**ADDENDUM PLANNING COMMITTEE
REPORT**

PLANNING SUB COMMITTEE A		AGENDA ITEM NO: B4
Date:	30 th October 2018	EXEMPT NON-EXEMPT

Application numbers	P2016/4928/FUL
Application types	Full Planning
Ward	Hillrise Ward
Listed building	n/a
Conservation area	None
Development Plan Context	Article 4 Direction – office to residential Cycle Routes (local) Rail Land Ownership – National Rail Surface
Licensing Implications	None
Site Address	469 Hornsey Road, Islington, London, N19 3QL
Proposals	Demolition of existing two storey building and erection of 4 storey building plus set back roof addition and part basement to provide office 226sqm (B1 use) at ground and part basement floor and 7 self-contained resident units (6 x 2 beds & 1 x 3 bed) over second to fourth floor levels plus cycle parking and associated refuse, removal of existing cross over and on street servicing and associated alterations.

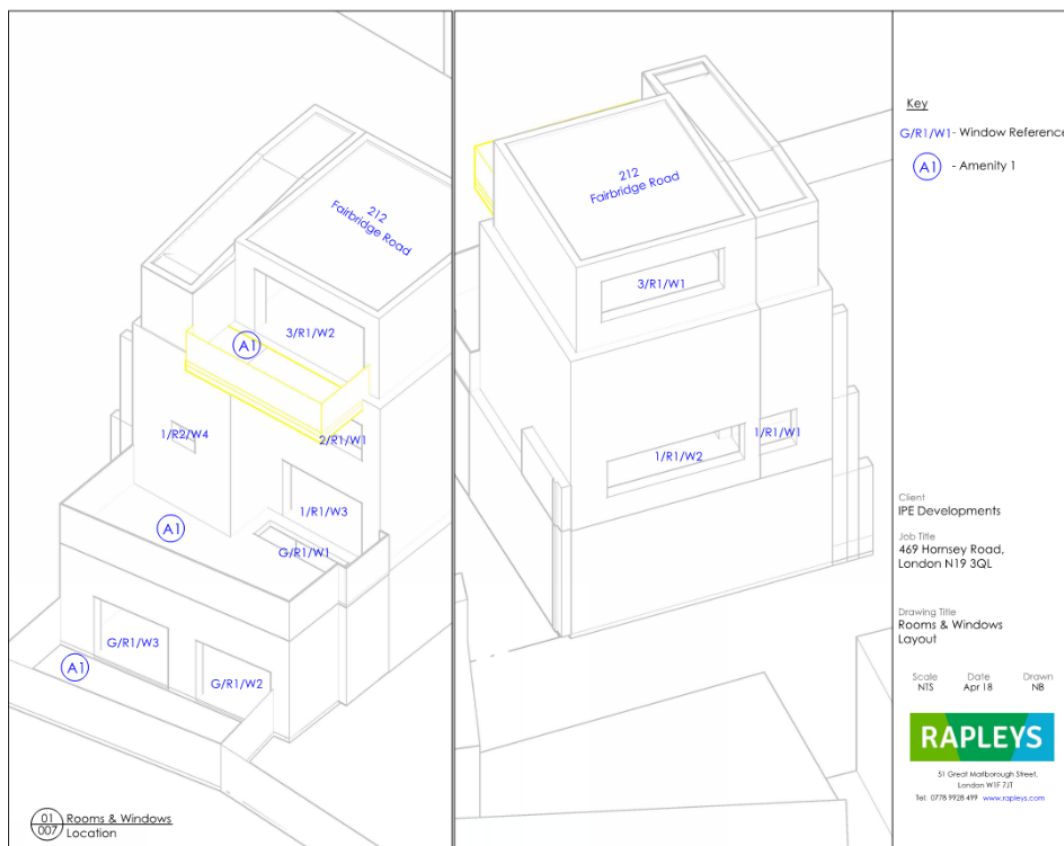
- 5.7 The new assessment outlines how the sunlight and daylight amenity to the residential accommodation of 212 Fairbridge Road has been retained.
- 5.8 The results table listed in the new assessment (included below) highlights that three windows do not meet the BRE VSC requirements. W1 of the ground floor Living/Kitchen/Dining area will have a reduced VSC from 38.66 to 23.69 (0.61). However, this window is a skylight and does not form one of the principle windows that allows light into the effected room. As the room benefits from large terrace doors that meet the BRE criteria, the reduction to W1 is considered acceptable.

- 5.9 W3 to the first floor has a reduction ratio of 0.77. This is only marginally below the 0.8 BRE requirement and as the room has two further windows that meet the BRE criteria the marginal reduction below the BRE criteria for W3 is considered to be acceptable.

- 5.10 First floor window W4 provides light to a non-habitable room (WC) and therefore the VSC reduction from 38.21 to 25.04 (0.65) will not have a detrimental effect on the living conditions for the inhabitants of the unit.

Ground Floor Plan (120-001-Q)

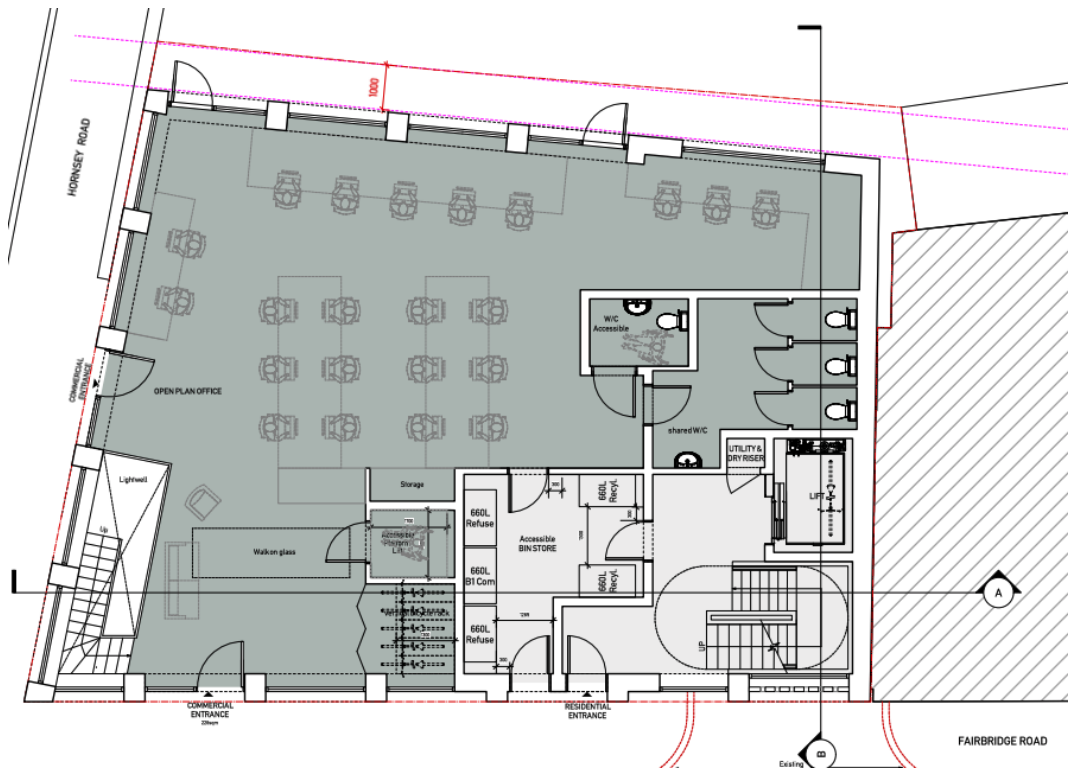
- 5.14 On the 15th June 2018 Network Rail removed their objection to the application on the basis that there is now a 1m clearance from the building face to the boundary fence with Network Rail Land, as can be seen on the Ground Floor Plan (120-001-Q). Network Rail also highlighted that the dynamics of the soil interaction with the building structures need further consideration during the design and construction phase. Condition 23 has been amended to address this issue.
